UTILITY PANEL UP-205 (CKT #2096)

REQUEST FOR INFORMATION NOT ADDRESSED IN THIS CCO REMAIN IN FORCE					
(2)	03/04/08	BARRIER MODIFICATIONS	JS BM	RG SE	44
(1)	02/19/08	ELECTRICAL MODIFICATIONS	MP EL	RR	42
MARK	DATE	DESCRIPTIONS	BY	CH'D	CCO#
REVISIONS

DETAILS
SAS SUPERSTRUCTURE ROADWAY EASTBOUND PANEL UP-205 SCHEDULE
NO SCALE

E-151

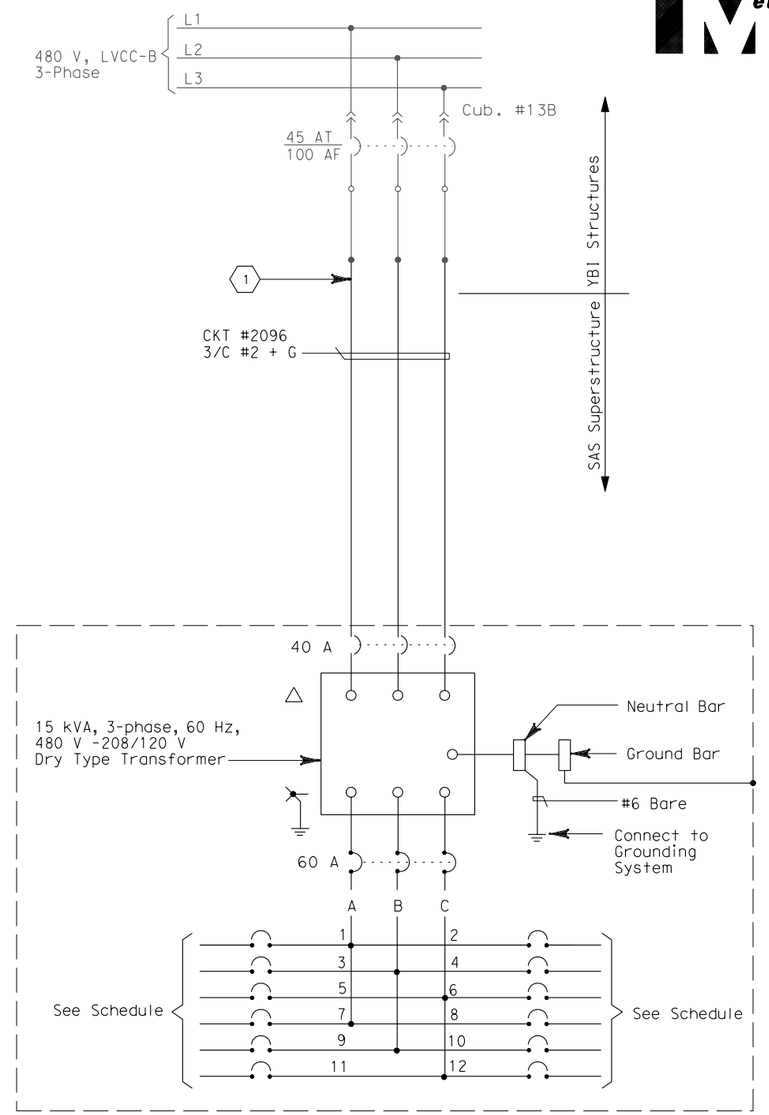
LOAD DESCRIPTION	LTG	REC	OTH.	CB		CB	LTG	REC	OTH.	LOAD DESCRIPTION
Recept (2) Eastbound North Barrier		360		20/1	1 A 2	20/1				Spare
Spare				20/1	3 B 4	20/1				Spare (2)
Recept (2) Service Platform #5		360		20/1	5 C 6	20/1				Spare
Recept (2) Girder		360		20/1	7 A 8	20/1	738			Girder Lighting (18)
RTU #10E (PLC Power Supply)			100	20/1	9 B 10	20/1				Spare
RTU-#10E (Lighting & Receptacle)	105	180	150	20/1	11 C 12	20/1				Spare
TOTAL WATTS	105	1260	250				738		(2)	TOTAL VA

TOTAL kVA: 2.363 (2)

Phase A - 0.720
Phase B - 0.100 (2)
Phase C - 0.795
